**RE: Toronto Preservation Board Meeting of June 22, 2017**  
**- Item No. PB24.1**  
**- Designation of the King-Spadina Heritage Conservation District**  
**under Part V of the Ontario Heritage Act**  
**- Notice of Objection filed on behalf of Sun Life Assurance Company of Canada**  
**re: 100 Simcoe Street and 211 Adelaide Street West**

**Re: 100 Simcoe Street, Inclusion on the City of Toronto's Heritage Register - Item No. PB20.2**

We have prepared this letter and the accompanying annotated photographs in response to the recommendation that City Council include 100 Simcoe Street on the City of Toronto's Heritage Register.

East elevation detail (1975) showing 4th storey windows originally had brick jack arches, not stone lintels

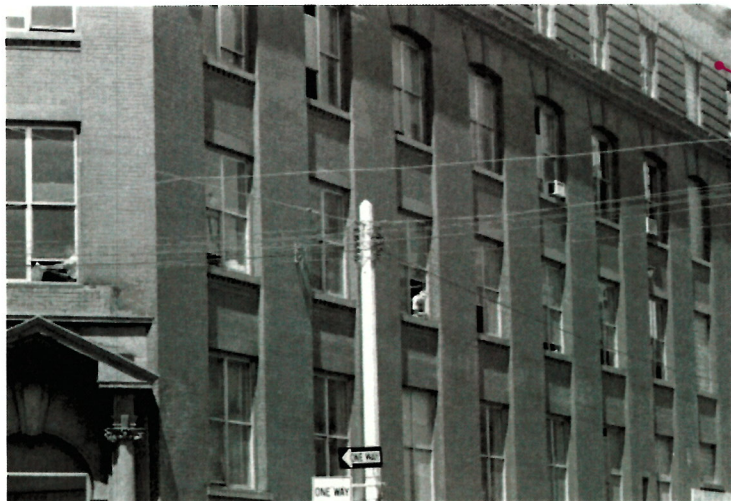
change to scale and proportion

oversized windows with no stylistic precedent in historic design

building orientation changed; entrance added
